TOWN OF CANMORE
AGENDA

1. APPEAL OF DEVELOPMENT PERMIT PL20250086

12 Blue Grouse Ridge; Lot 35 Plan 9612010

Appeal against an approval of the Development Officer of a Detached Dwelling with
Variance to the Gross Floor Area

Figure 1 – The proposed dwelling is subject to increased developer-imposed setbacks.

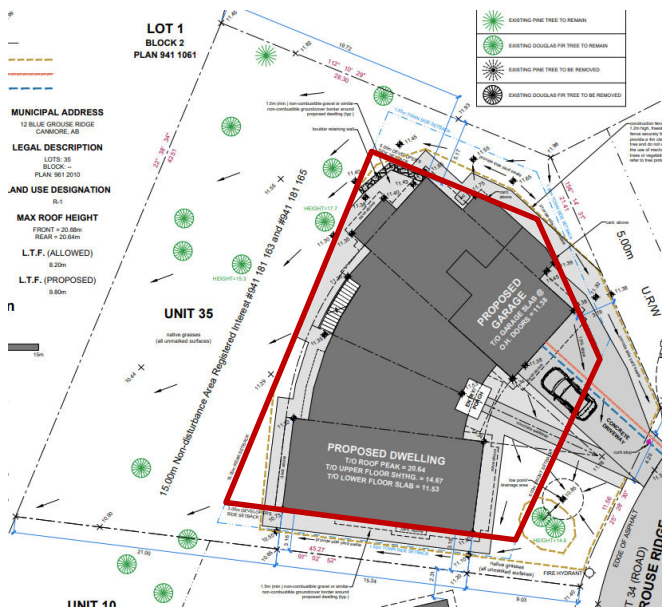
The Planning and Development Department supports the proposed variance to increase the Gross Floor Area (GFA) beyond the maximum allowed by the Land Use Bylaw. Due to the larger than average size of the lot and increased setbacks required by the developer, the resulting site coverage of the proposed development is 25%, significantly below the 40% permitted in the R1 District. While the proposal does include increased building mass of 51.6 square meters (approximately the size of a two car garage), the impact of increased massing is offset by the open space which results from reduced site coverage.

The proposed development complies with all other Land Use Bylaw requirements including height, projection, and setbacks from property lines (see Figure 2 below, attachment 3 for complete Bylaw Conformance review, and attachment 4 for the Development Permit Application and Supporting information). During the review stage of the application, neighbourhood concerns were raised regarding visual overlook into adjacent properties from the proposed rear deck. The Land Use Bylaw does not contain regulations preventing visual overlook in this case.

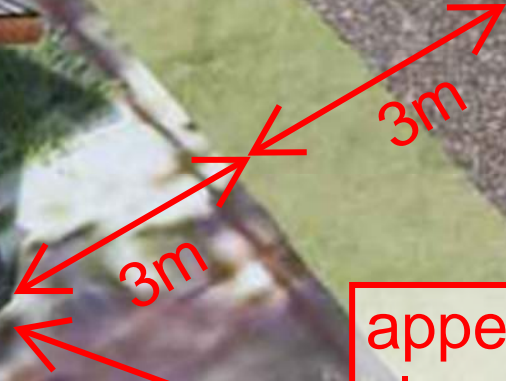
0.833m below
maximum roof
height

13 BGR closest
point 21.3m

eaveline
reduced mass on 2nd level
lower eaveline

14 BGR closest
point 17.5m

3) SilverTip Guidelines, Setbacks, Height and Good Design

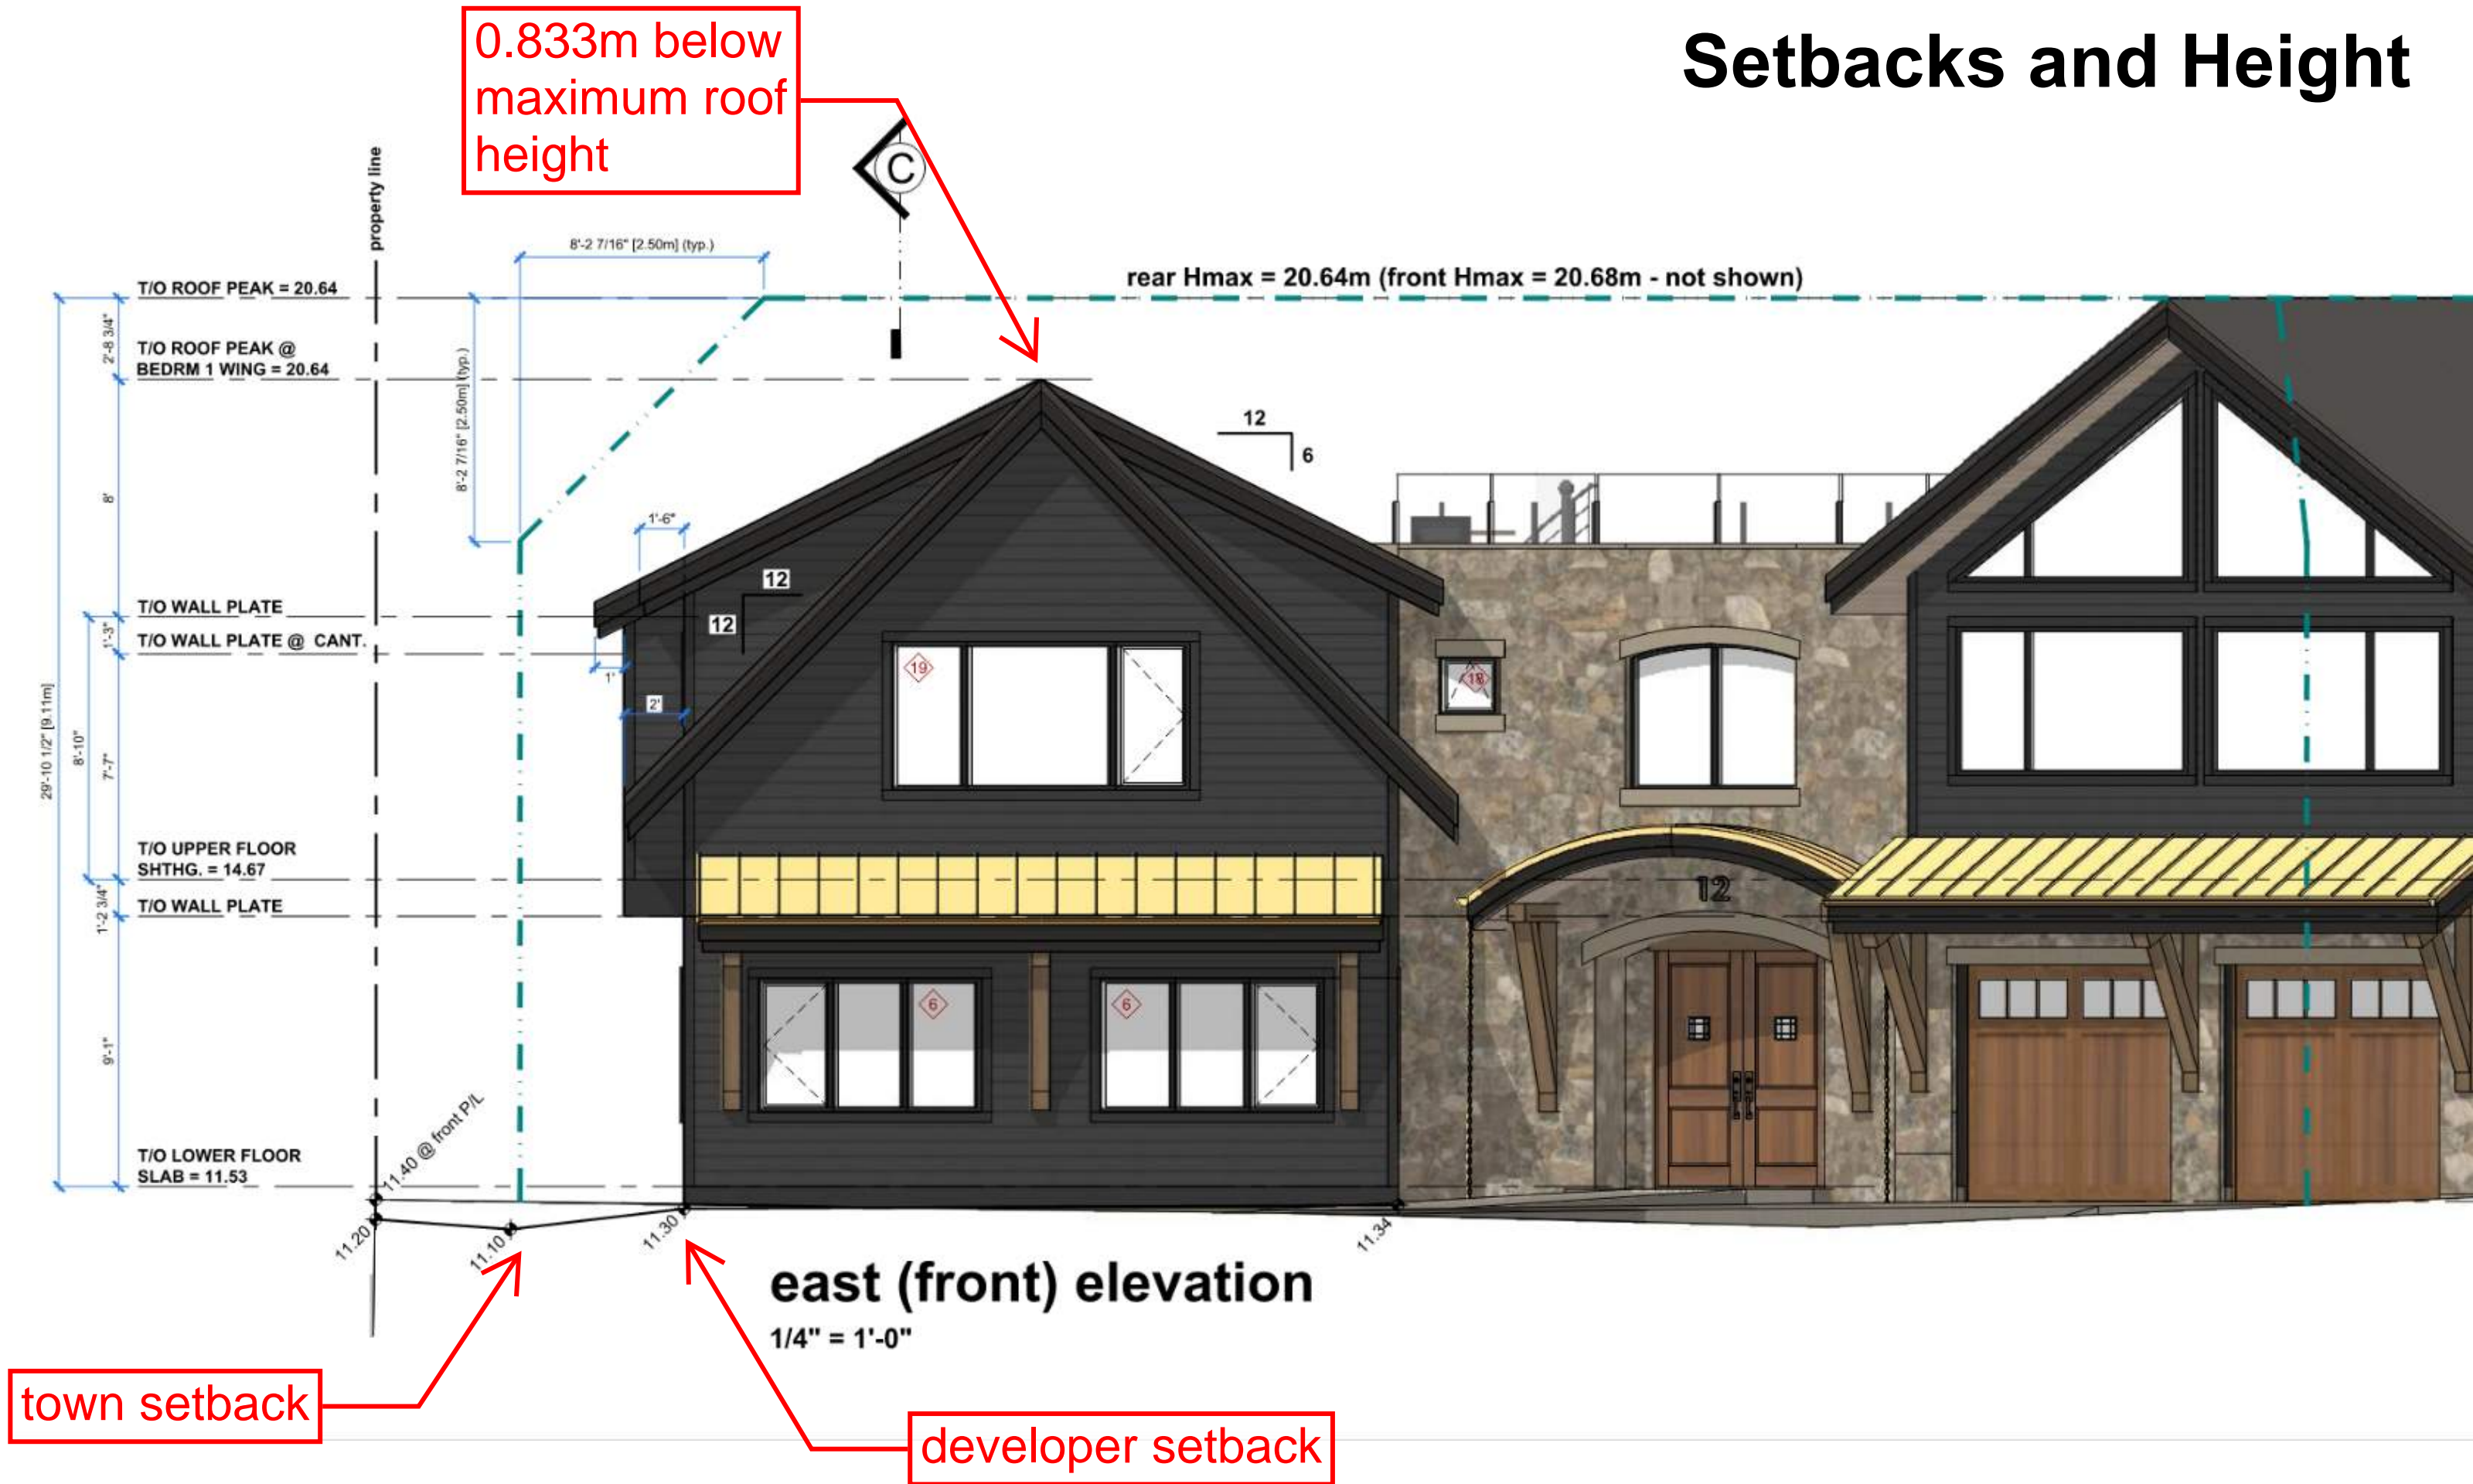
Reasons given to deny 9% variance

Guidelines - The proposed Detached Dwelling complies with all SilverTip Resort Guidelines and bylaws; the variance and appeal is to the Town. NOTE; this is a new Town limitation on maximum size of properties in this subdivision

Setbacks – The proposed Detached Dwelling is within all SilverTip Resort and municipal setbacks.
